Device TC1767ED
Marking/Step EES-AD, ES-AD
Package PG-LQFP-176-4

This Errata Sheet describes the deviations from the current user documentation.

Figure 1 Timing concerning equidistant multiple timers

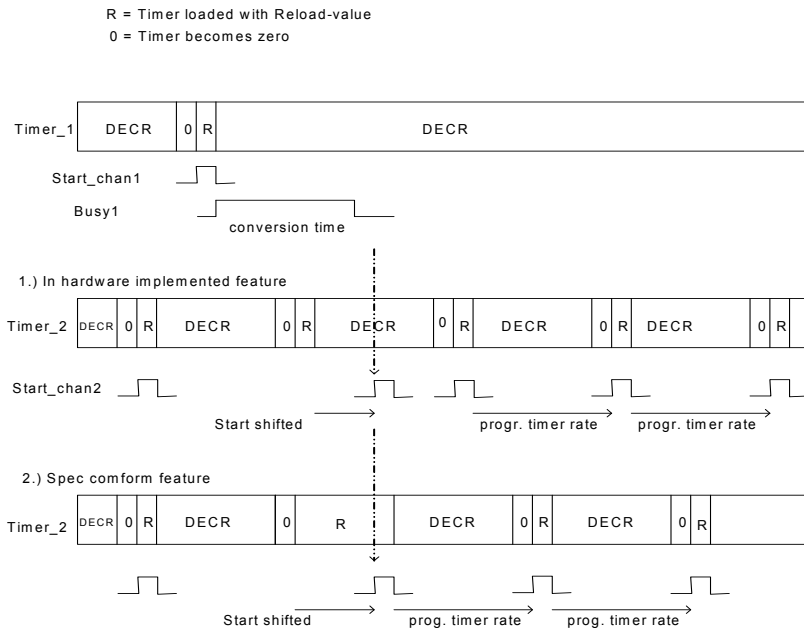
`Timer_1` and `Timer_2` are running with different reload-values. Both timers should start conversions with the requirement of equidistant timing.

`Timer_1` becomes zero and starts a conversion. `Timer_2` becomes zero during this conversion is running and sets the conversion-request-bit of `channel_2`. At

The correct behavior would be a reload when the requested conversion (of channel_2) is started.

Therefore the start of conversion for channel_2 is delayed by maximum one conversion-time. After this delay it will be continued with equidistant conversion-starts. Please refer to the following figure.

Figure 2 Loss of Arbitration

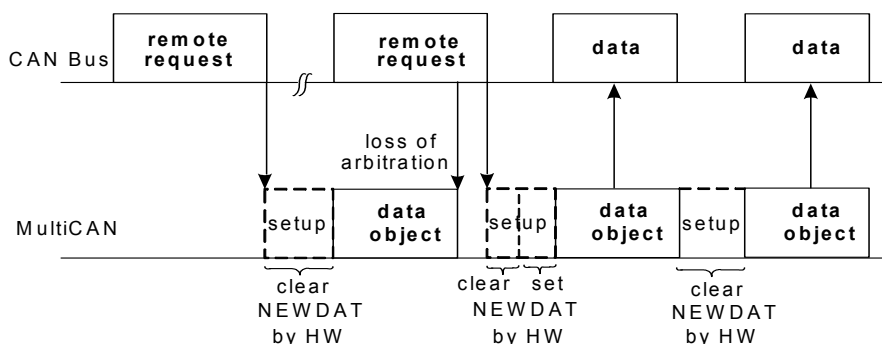
When the appropriate message object (data frame) triggered by the first remote frame wins the arbitration, it will be sent out and `NEWDAT` is not reset. This leads to an additional data frame, that will be sent by this message object (clearing `NEWDAT`).

There will, however, not be more data frames than there are corresponding remote requests.
